SEWAGE DISPOSAL SYSTEM

DEPARTMENT OF HEALTH AND MENTAL HYGIENE

REPAIR - PURPOSE - SEPTIC SYSTEM HAS FAILED.

HOUSE LOCATION

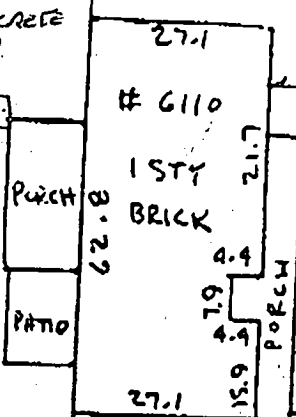
SITE INSPECTION FOR SEPTIC EVALUATION TO SUPPORT ADDITION OF 1 BEDROOM + BATH. SEE NOTE BELOW.

LOCATE ADJOINING LOT TO REAR
POSSIBLE RELEAS REPAIR
PROPOSAL TO ADD 3RD BEDROOM

OK, MAYBE FOR REAR ADDITION IN VICINITY OF PARTIAL
REWORK SCALED SITE PLAN WITH LOCATED SEPTIC RE
6110 TULANE RD
CLARKSVILLE, MD.

ADJOINING LOTS - 1 AT
REAR AND 2 NO LOT TO LEFT
HAVE DEED SYSTEMS
